SITE PLAN REVIEW

LOT NO 59 REGISTERED PLAN 43M-1981

OSTIENSE
CITY OF BRAMPTON

SITING
CARL FINLAY DRIVE
LOT 59

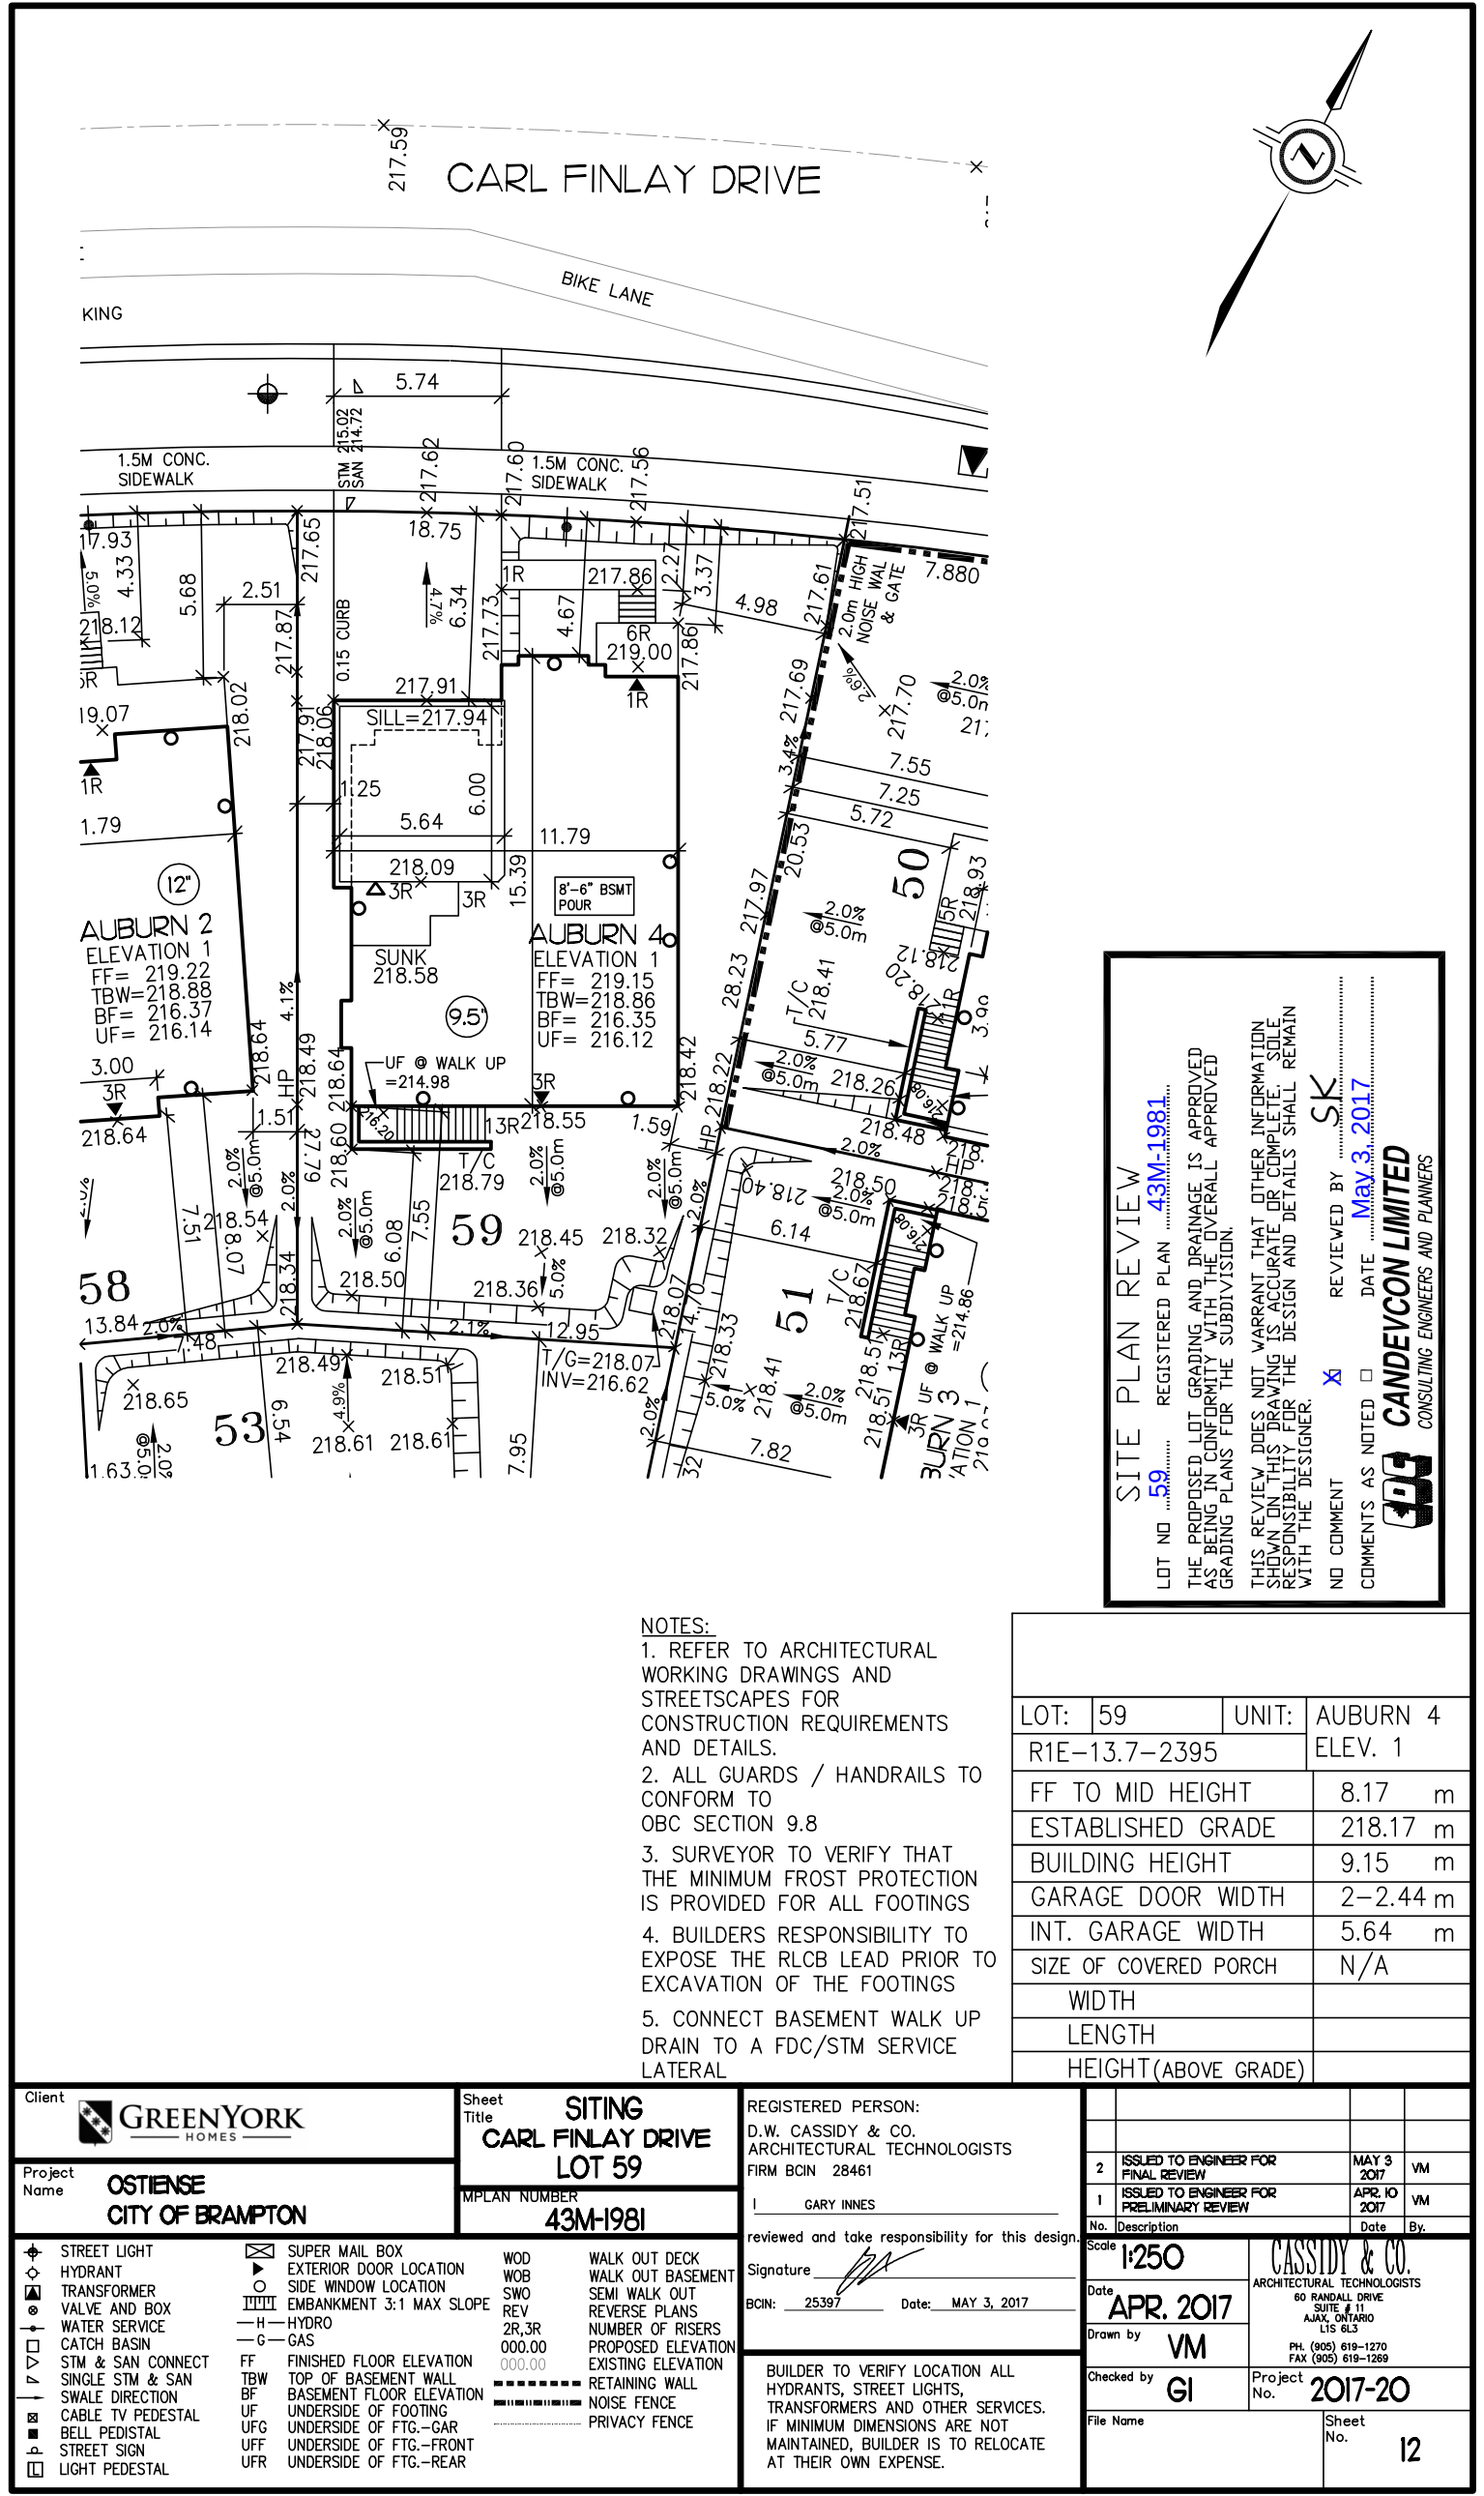
THE PROPOSED LOT GRADING AND DRAINAGE IS APPROVED AS BEING IN CONFORMITY WITH THE OVERALL APPROVED GRADING PLANS FOR THE SUBDIVISION.
